Village of Arlington Heights
Plan Commission
Board Room
Arlington Heights Village Hall
33 S. Arlington Heights Road
Arlington Heights, IL 60005
September 30, 2015
7:30 PM

- A. The Moorings - 811 E. Central Rd. - PC#15-012
PUD Amendment
- B. Collision Damage Experts - 9 E. College Dr. - PC#15-018
Land Use Variation

VOLUME I CIVIL DRAWING NO.: 2014104 COMMISSION NO.: 2014104		RENDERING DATE: 06/26/2015 SCALE: AS NOTED		REVISIONS NO. DATE DESCRIPTION		FOR THE MOORINGS OF ARLINGTON HEIGHTS PRESBYTERIAN HOMES 811 EAST CENTRAL ROAD, ARLINGTON HEIGHTS, IL 60005 DRAWN BY: J.S.D. COORDINATED BY: C.S.L. CHECKED BY: J.F.H. APPROVED BY: C.P.K.		rtps architects® architecture • master planning • interior design 250 VALLEYBROOK DRIVE, LANCASTER, PA 17601 717-560-9501 FAX: 717-560-2373 RLPS, LLP		PLANNING COMMISSION SUBMISSION	THIS DRAWING IS AN INSTRUMENT OF SERVICE. IT IS THE PROPERTY OF RLPS ARCHITECTS, P.C. AND IS NOT TO BE REPRODUCED WITHOUT THE ARCHITECT'S PERMISSION AND UNLESS IT BEARS THE NAME OF THE ARCHITECT. CONTRACTOR SHALL VERIFY ALL DIMENSIONS AND CONDITIONS AT THE SITE BEFORE PROCEEDING WITH THE WORK.	
--	--	--	--	-----------------------------------	--	--	--	--	--	----------------

ZONE D: RETENTION POND LANDSCAPE PLAN

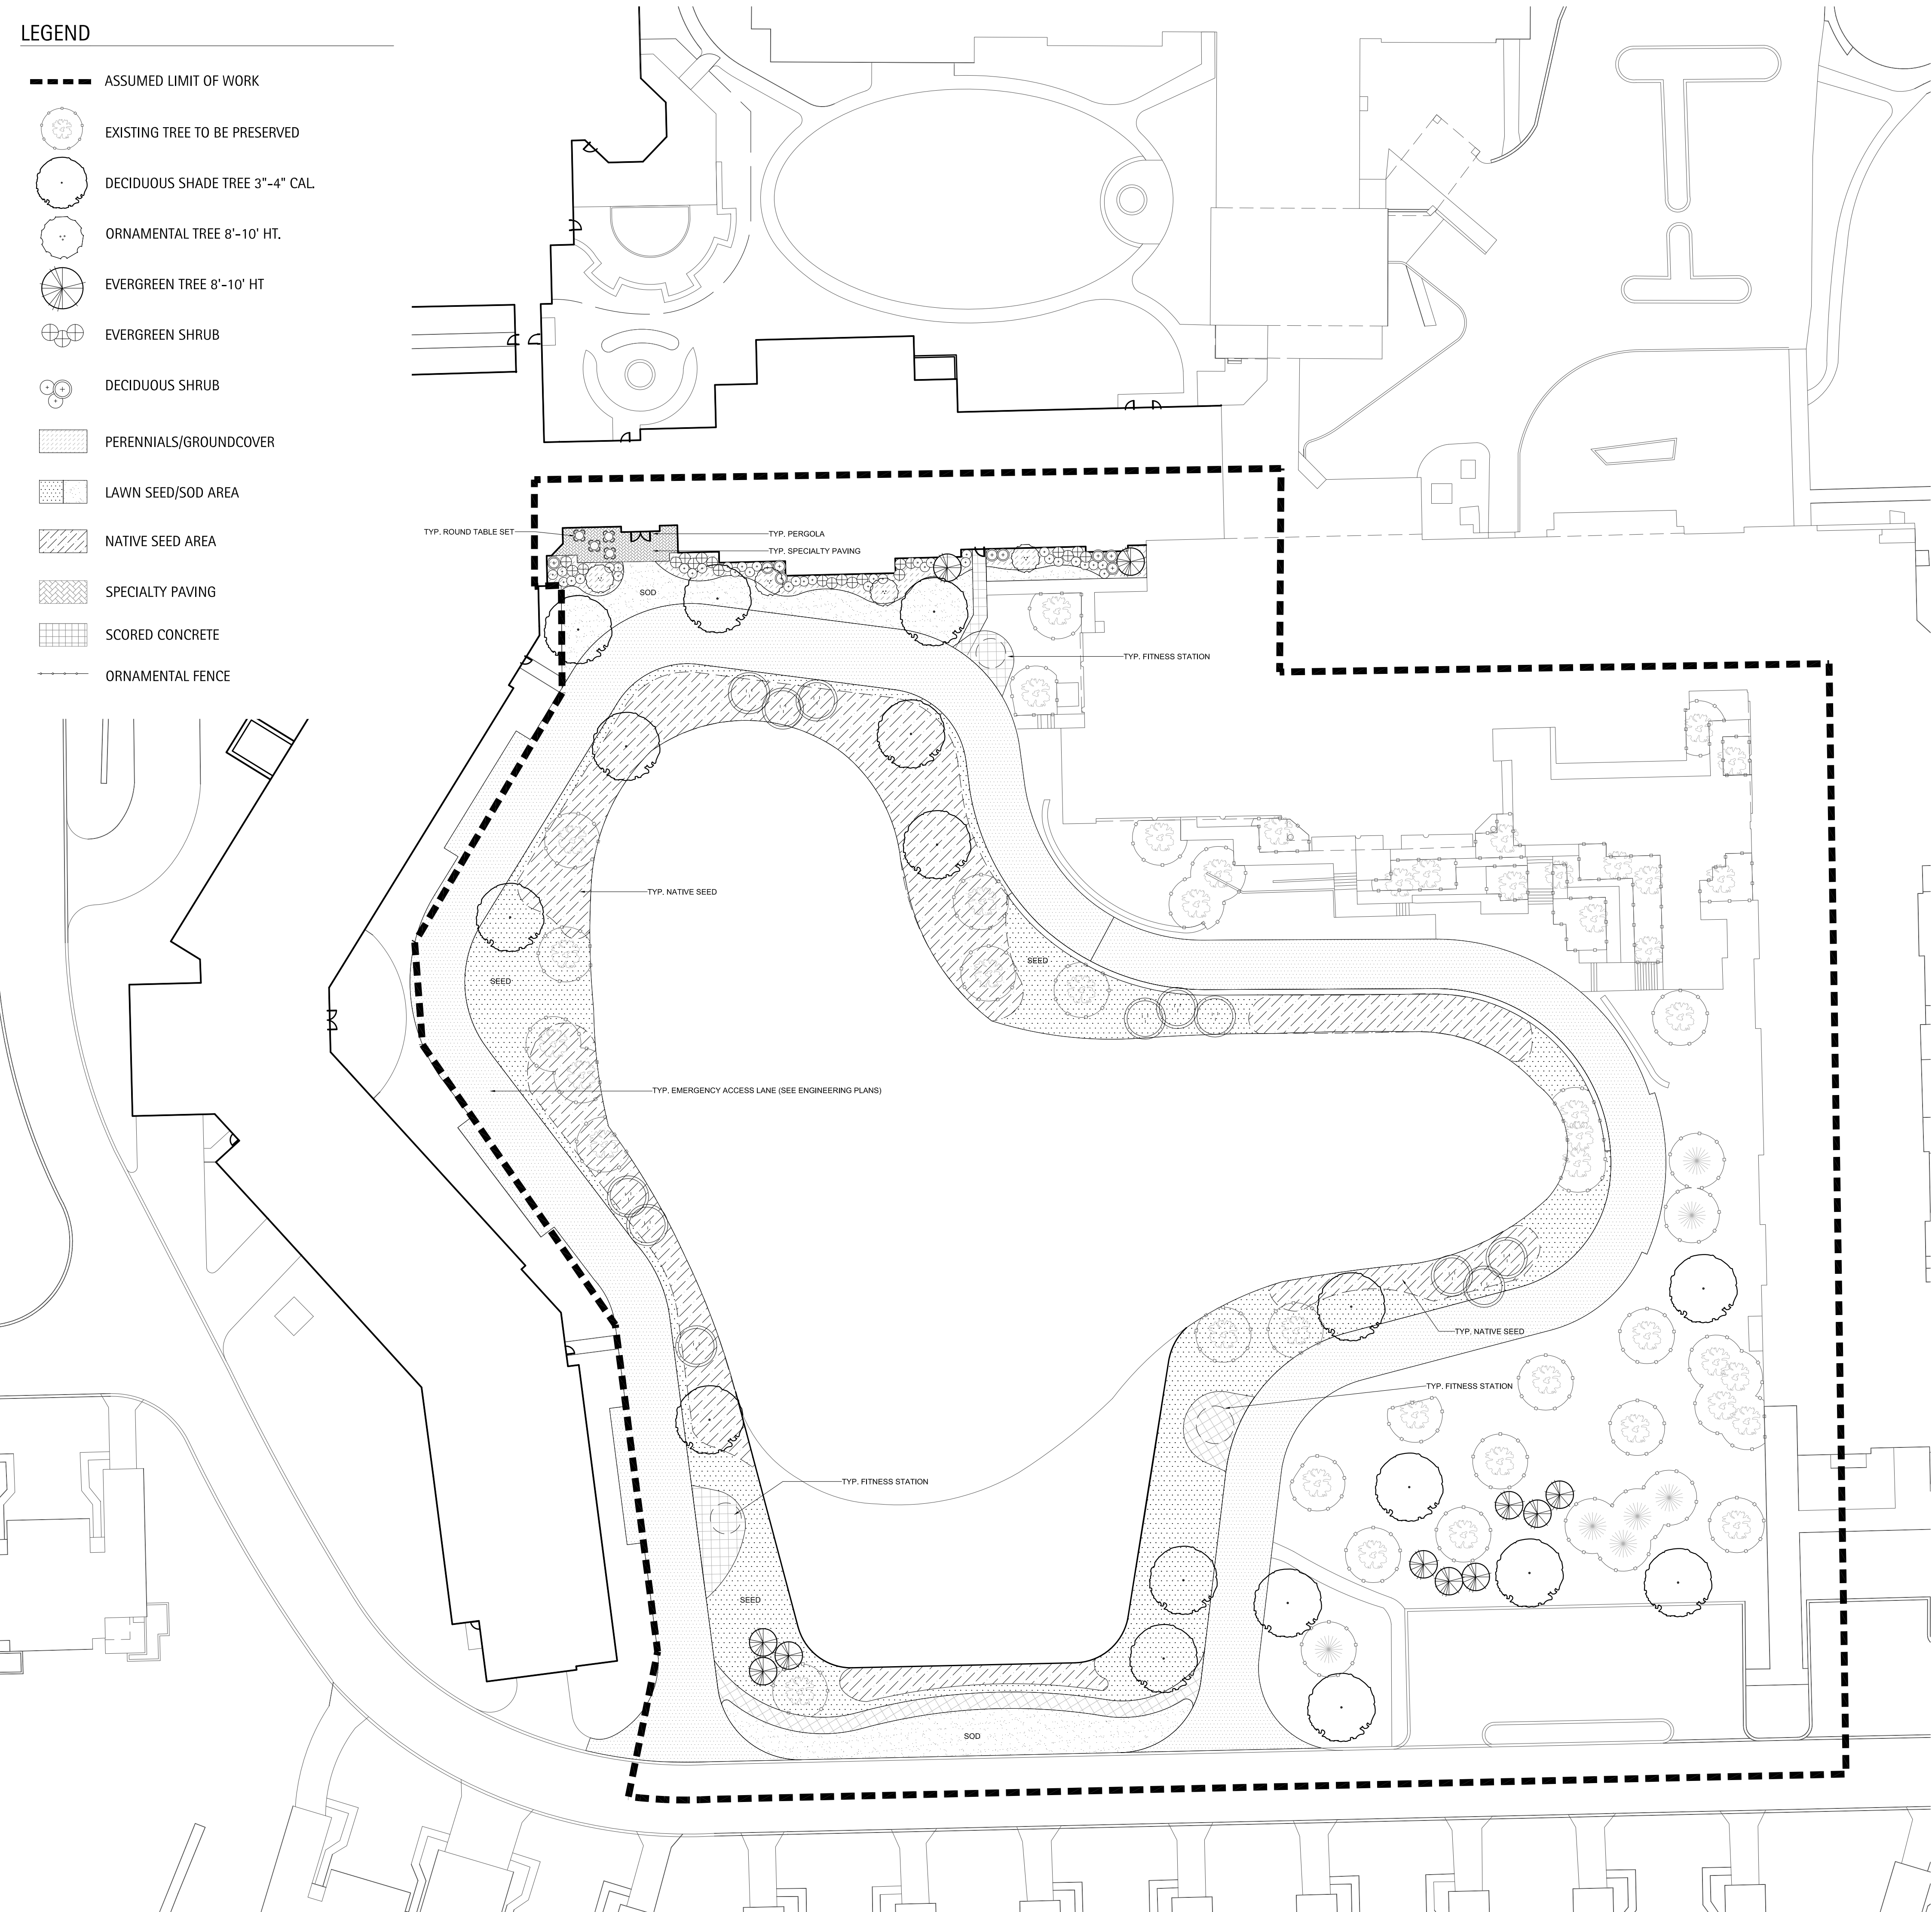
12. On Sheet L-02, the parking row on the west of the Memory Care Assisted Living is deficient 2 landscaping islands. Revise to include islands. Also, please clarify if there is a landscaping island at the south end of the east row of parking.
13. It appears that the opposing walls of inner courts are spaced at least 100 feet apart. Please confirm compliance with Section 5.1-8.11, Spacing between multi-family buildings, including court standards.

12. Sheet L-02 has been revised to incorporate landscaping islands that meet the standards set forth in the "Requirements for Landscape Approval" document supplied by the Village Planning Department. There is a landscaping island at the south end of the east row of parking. This island is shown on Sheet L-04.

3. Additional trees have been added to the landscape plan at the south end and east end of the parking areas shown on Sheets L-02 & L-04.
4. Landscape screening has been identified on Sheet L-04 and mechanical units have been located away from the front elevation.

5. Landscape screening of the loading area has been identified on Sheet L-04.
6. All required fees and bonds will be provided at time of permit.
